~~2020~~2023 Vermont Commercial Building Energy Standard AMENDMENTS

These rules are adopted under 30 V.S.A. § 53. This document shall be known and cited as the 2023 Vermont Commercial Building Energy Standard Amendments. ~~The 2020 Vermont Commercial Building Energy Standard Amendments. The 2018 International Energy Conservation Code (IECC) Standards~~ (First Printing: ~~August 2017~~) and ~~ANSI/ASHRAE/IES Standard 90.1-2016 Energy Standard for Buildings Except Low-Rise Residential Buildings~~ July 2020) published by International Code Council (ICC), Inc., as amended herein, are incorporated by reference and are available on the ICC website at: www.iccsafe.org. ~~The IECC is amended herein as follows.~~

FIGURE C405.2.4.2(1)
PRIMARY AND SECONDARY SIDELIT DAYLIGHT ZONES

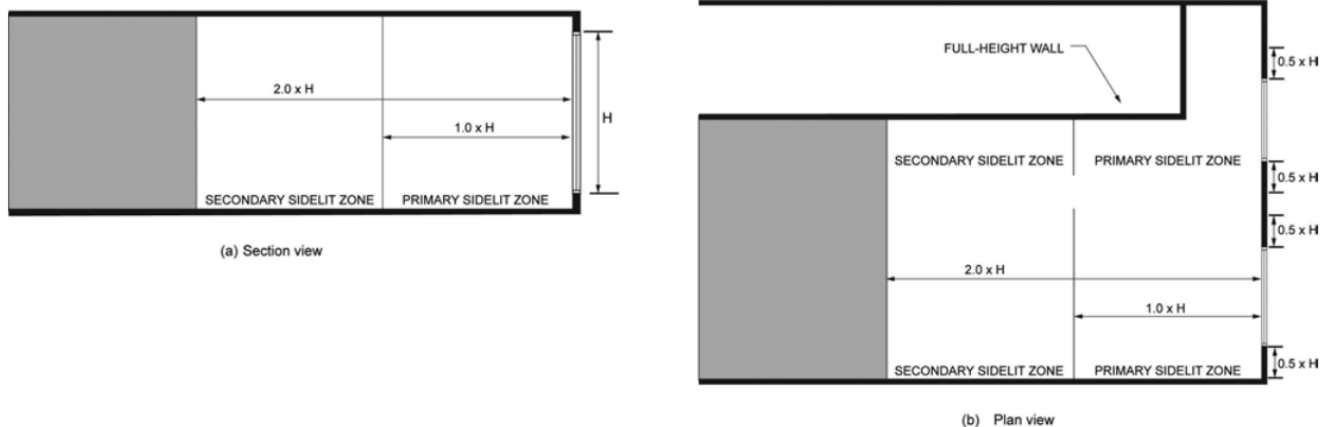
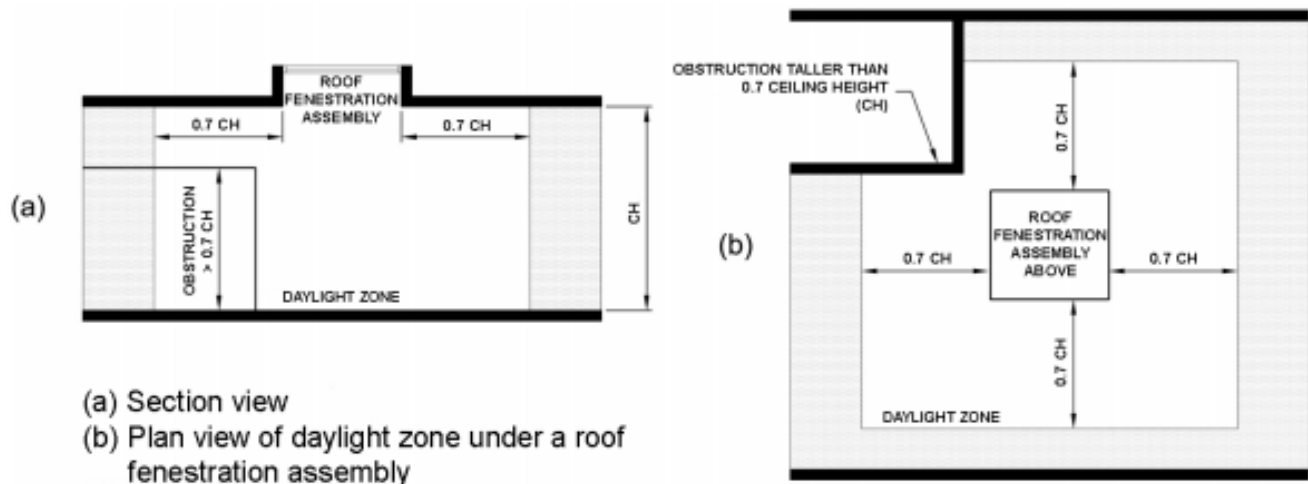
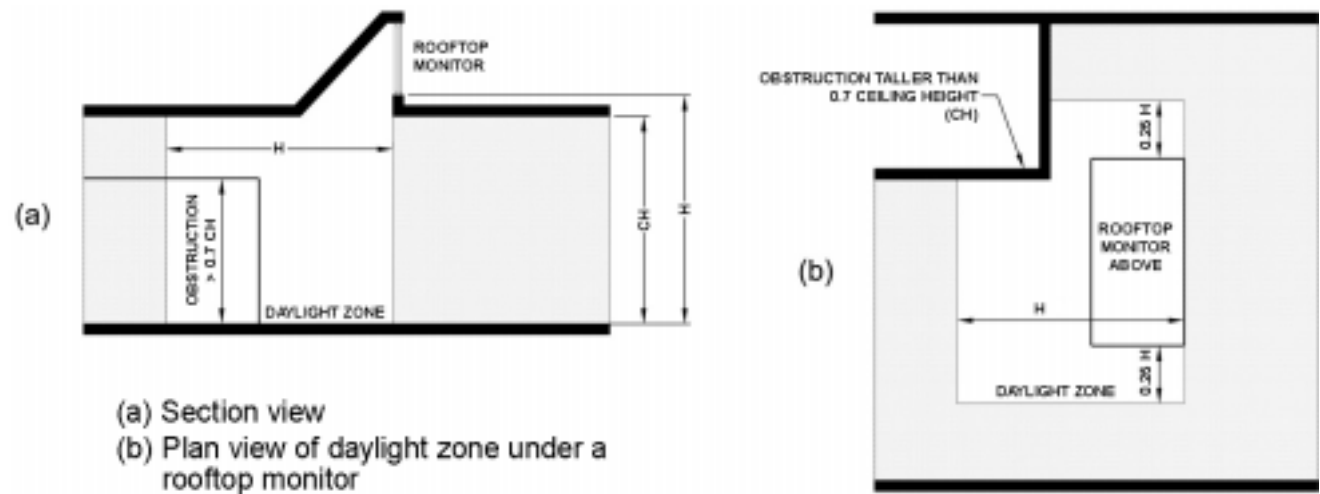
~~—delete and replace—~~

FIGURE C405.2.4.3(4)

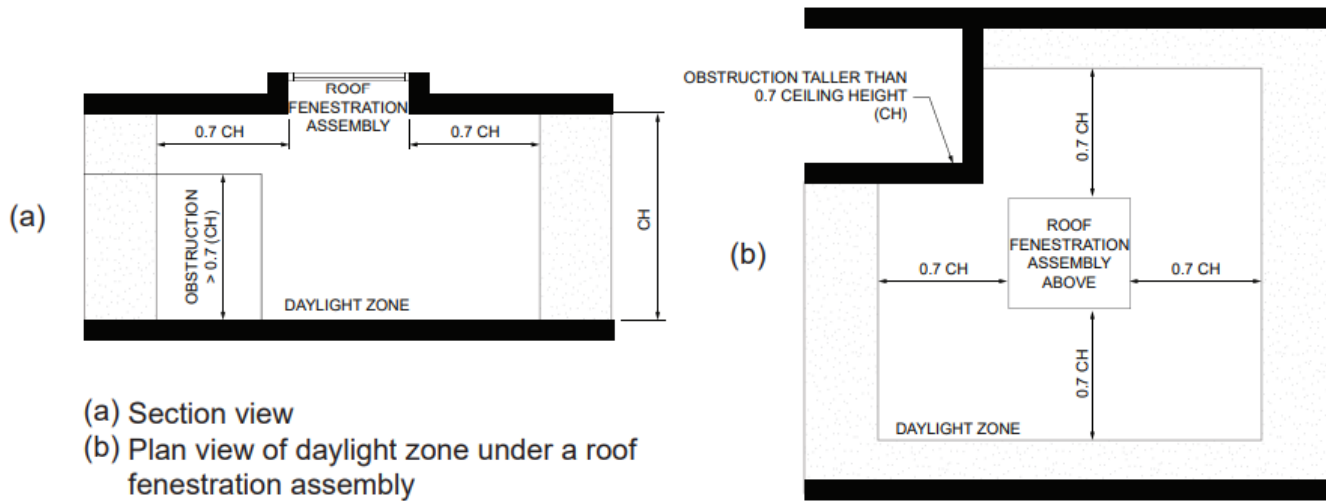
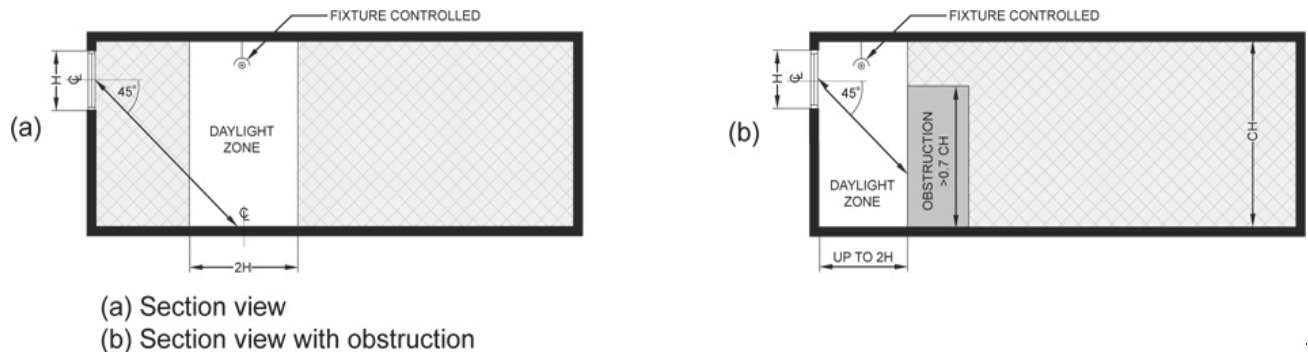
—add—

TOPLIT DAYLIGHT ZONE ~~ADJACENT TO CLERESTORY FENESTRATION IN A WALL~~

FIGURE C405.2.3-3(4)

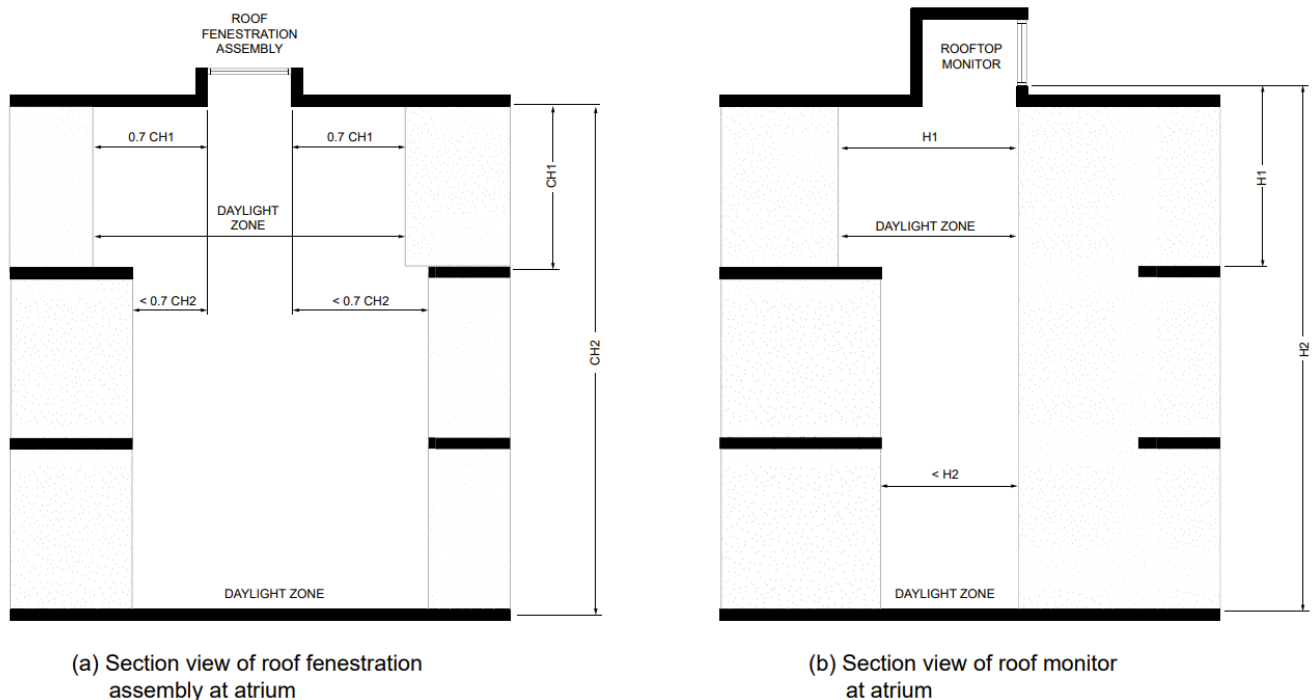
add C405.2.4.4 Atriums. Daylight zones at atrium spaces shall be established at the top floor surrounding the atrium and at the floor of the atrium space, and not on intermediate floors, as indicated in Figure C405.2.4.4.

DAYLIGHT ZONE ADJACENT TO CLERESTORY FENESTRATION IN A WALL ZONES AT A MULTISTORY ATRIUM
